Special Bulletin **SB-10060328-8666** **SP15-21**

REAR JCT BOX COVER UPGRADE

On the vehicles affected by this bulletin, to prevent premature corrosion of the rear junction box components, replace the junction box cover with a late model "central mount" cover.

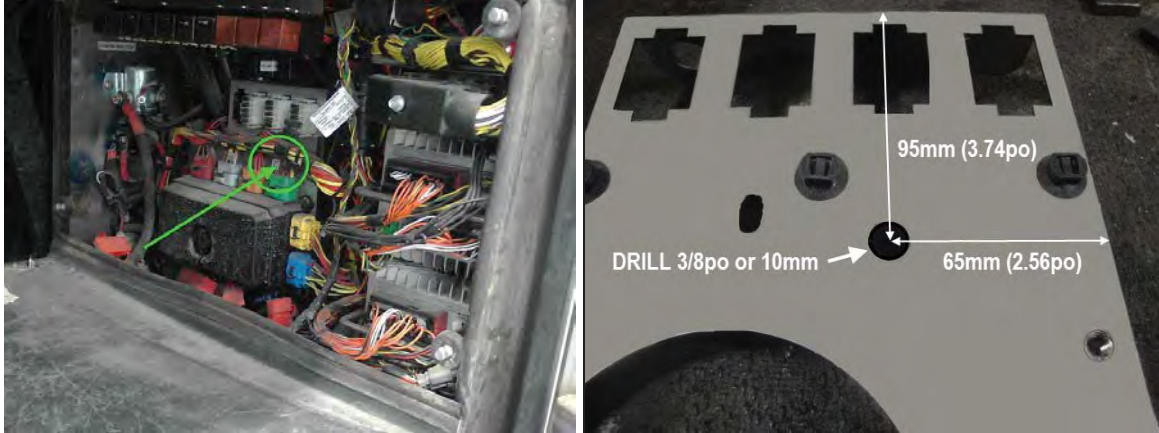
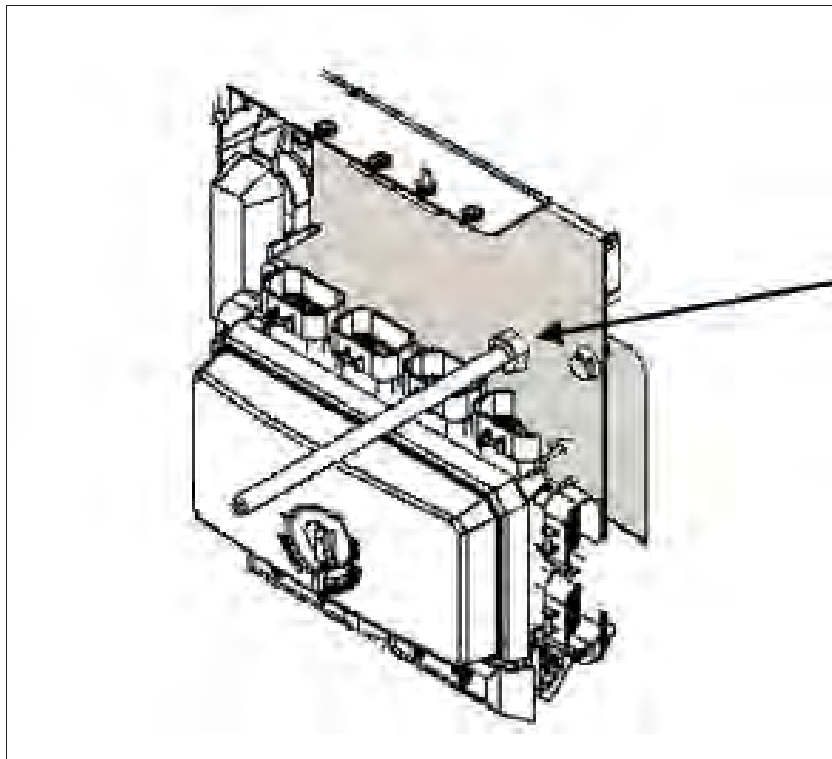
- 2) On the fuse box back plate, drill a 3/8" (10mm) hole following the template and image below (move away wires and harness as required).

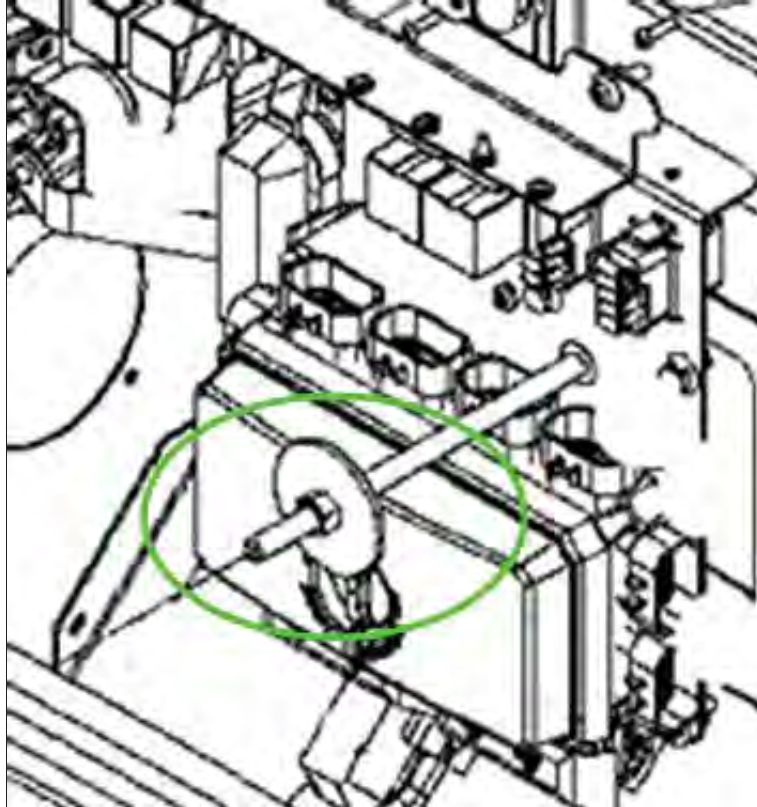
- 3) Insert a 3/8" stainless steel threaded rod of the correct length in the previously drilled hole (rod must stick out of the new central mount cover about 1/2" min), secure the rod to the back plate using two #500102 3/8 SS nuts, one on each side of the plate.

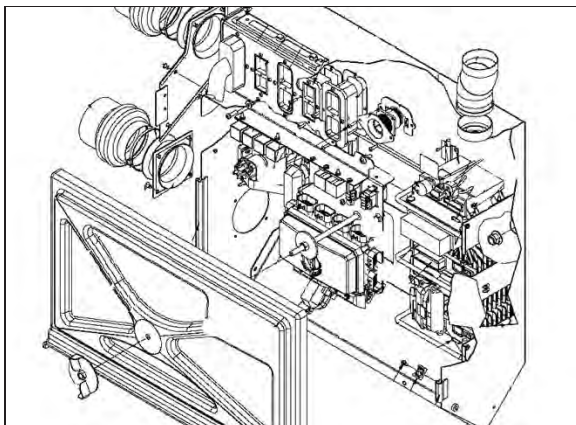
- 4) Install the #068704 washer on the rod (secured with a #500102 3/8 SS nut on both sides) at about one inch below the cover wing nut flange.
